Service Bulletin

TAT SB08-01

Issued: February 8, 2008
Model SR22 w/ Tornado Alley
Turbo, Inc. Turbonormalizer
installed pursuant to Engine
Technologies, Inc. STC
SA10588SC on Cirrus Design
Corporation Model SR 22 aircraft

The purpose of this Service Bulletin is to inform affected owners and operators of a minor alteration to an exhaust component required for improved durability of the tailpipe assemblies.

Figure 1. Right side shown.
Left Side Similar.

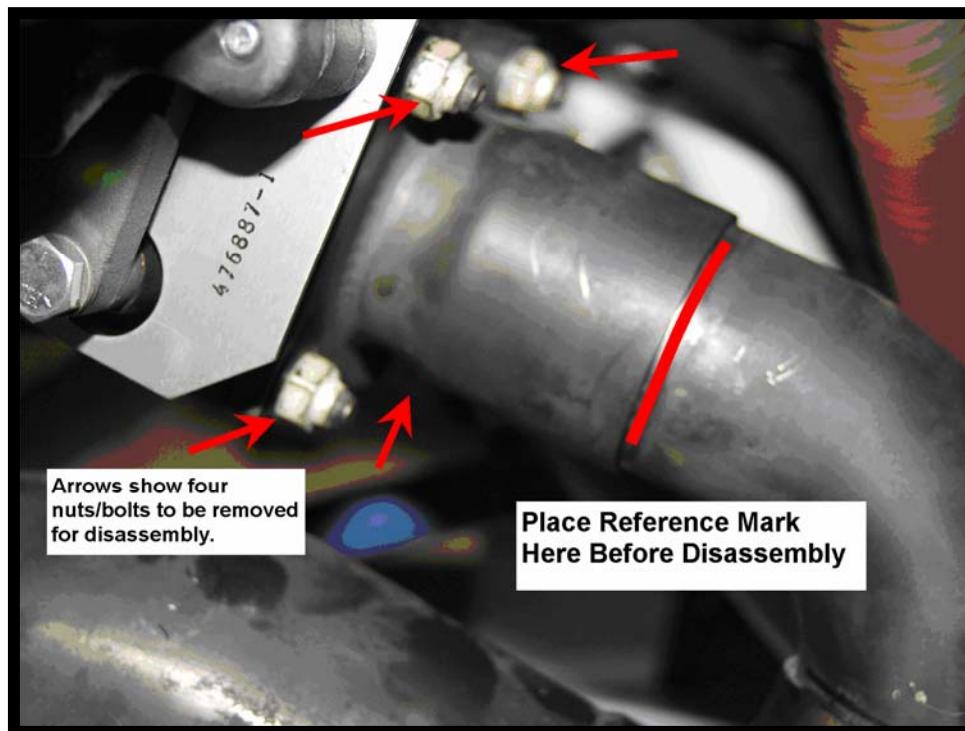
- b. Visually locate the wastegate outlet on the aft side of the right hand wastegate. See Figure 1. Disconnect the heater hose clamp and hose from the intercooler to facilitate inspection and access.

- c. Visually inspect the right angle exhaust elbow and the area where the elbow inserts into the tailpipe, for any signs of a crack in the weld of the vertical receptacle in the tailpipe into which the short leg of the right angle elbow is inserted. If any cracks are observed, then contact Tornado Alley Turbo, Inc. for replacement parts before return to service or further flight.

- f. Remove the four nuts and bolts securing the wastegate outlet flange and swaged 1.75" tube into which the right angle exhaust elbow is inserted.
 - g. Lift on the 1.75" diameter exhaust elbow and remove both components from the aircraft. In some cases, some modest interference of the wastegate flange with the wastegate may exist, but in almost all cases, the elbow and wastegate outlet should be able to be removed without further disassembly of the exhaust system.

- i. Measure the length of the elbow from the previously applied reference mark to the end of the long leg of the elbow.
 - j. If this measurement is greater than 1.00", shorten the elbow so that the engagement, when re-installed, will be no more than 1.10" and not less than 1.00" as measured from the reference mark.

- k. If the engagement length is less than 1.00" but is more than 0.90" then simply re-install the elbow. If the engagement is less than 0.90" then contact Tornado Alley Turbo, Inc., for a replacement elbow.

2. Re-install the elbow and the wastegate outlet assembly as follows:
 - a. Re-install wastegate outlet with the right angle exhaust elbow properly inserted into the wastegate outlet and the tailpipe.

- e. Torque nuts to 70 in-lbs.
3. Complete the aircraft records by noting compliance with Service Bulletin TAT SB08-01 in the aircraft logbook.
4. Return the completed "TAT SB08-01 Service Bulletin Information Sheet" and all replaced parts, if any, to Tornado Alley Turbo, Inc. for warranty credit.

Figure 2.
Left side.
Showing where to place reference mark before disassembly.

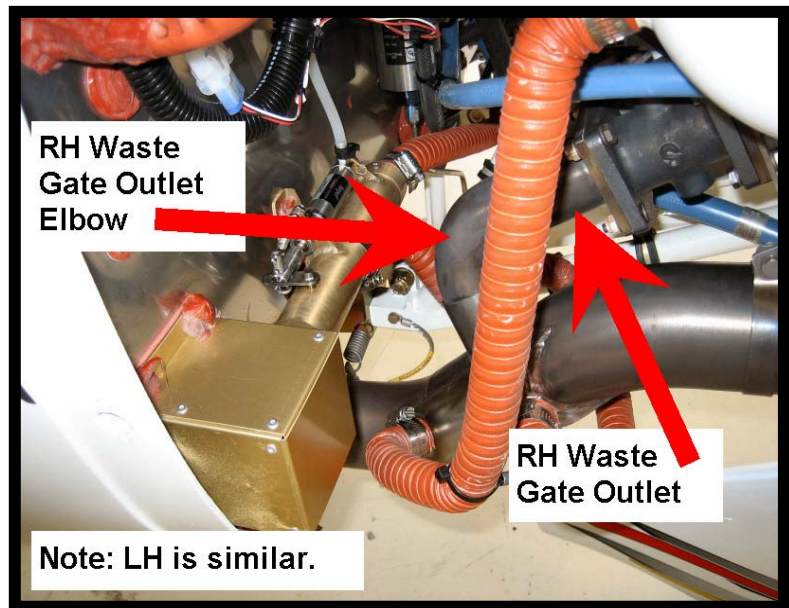
- d. Clean the area where the elbow is inserted into the wastegate outlet tube.
 - e. Mark the exhaust elbow at the aft end of the wastegate outlet tube.

- h. Remove the exhaust elbow from the wastegate outlet swaged tube and clean any exhaust residue from the elbow and wastegate outlet tube assembly. **Be careful to preserve the previously applied reference mark.**
